ADDENDUM NO. 4:

Date: February 13, 2026
 Project: Verbena HS Gym
 DCM# 2025629
 WSM# 25-032

Owner: Chilton County Board of Education
 Architect: Ward Scott Morris Architecture, Inc.

PROJECT: Verbena HS Gym	ENG #2559 ARCH #25-032 DCM #2025629	DATE: February 13, 2026
-----------------------------------	---	-----------------------------------

C301

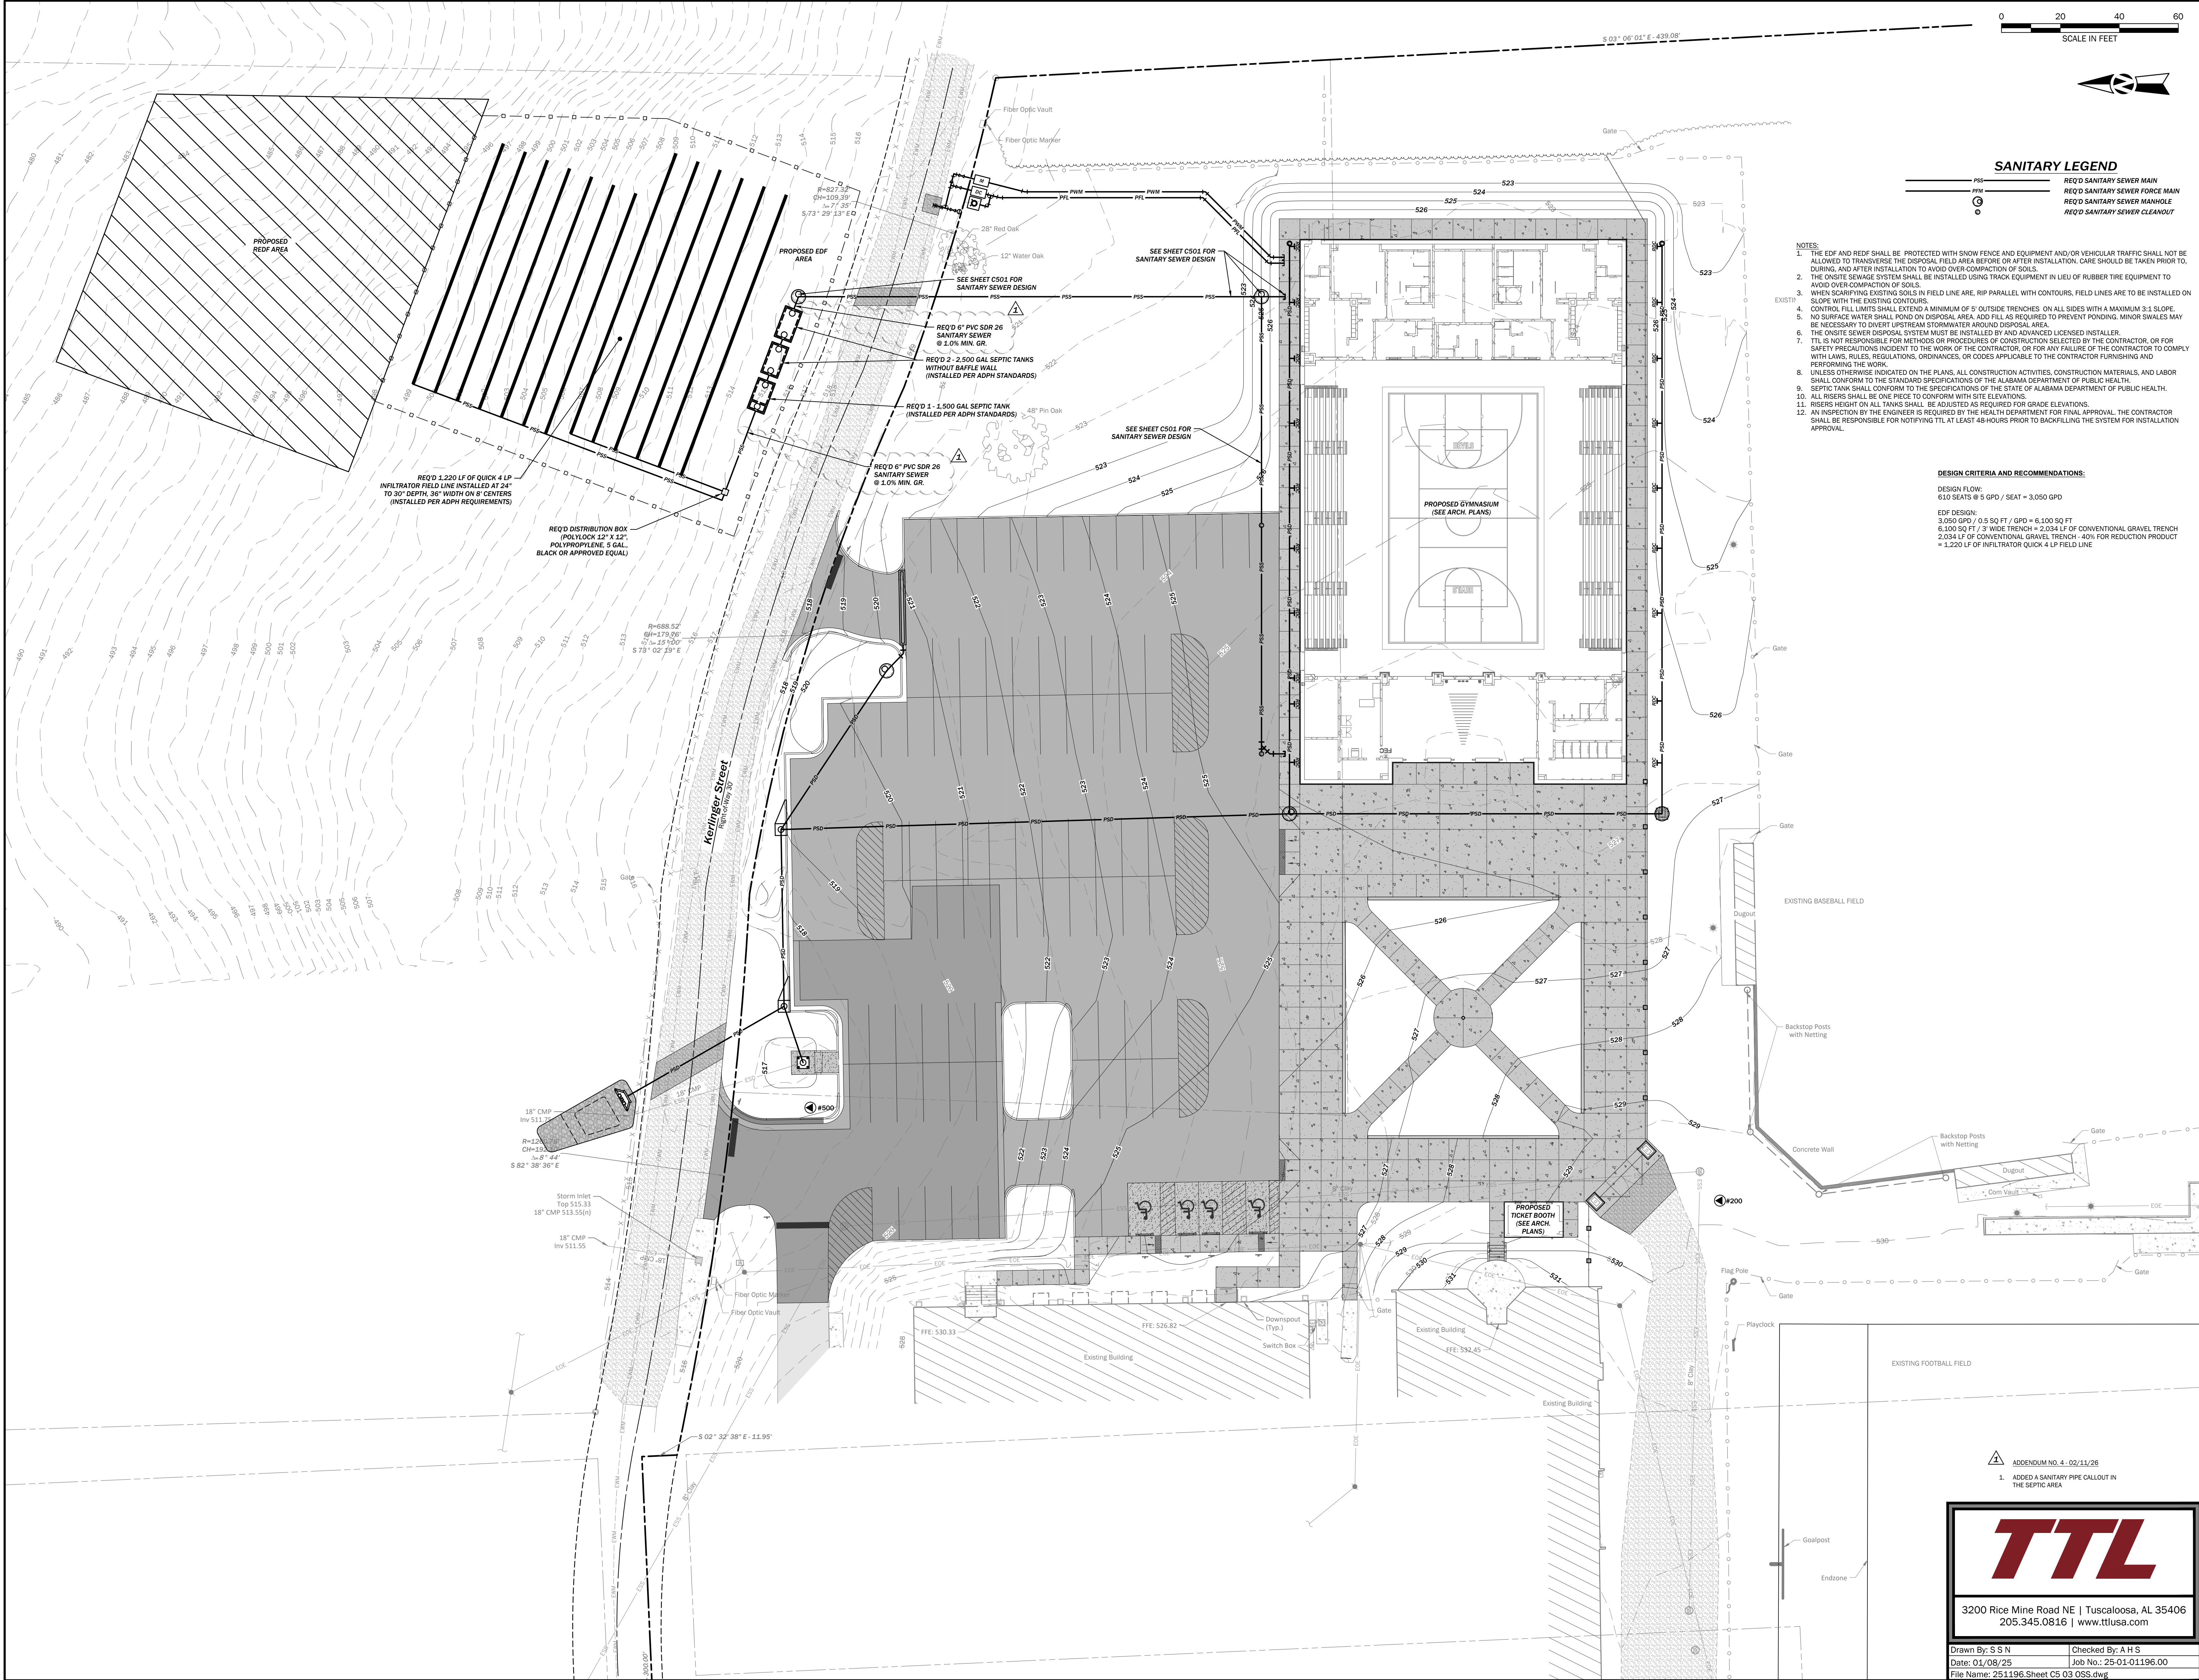
ADDENDUM NO. 4 - 02/11/26

- UPDATE REQUIRED IMPROVEMENTS ALONG KERLINGER STREET DUE TO WATER SYSTEM REVISIONS.
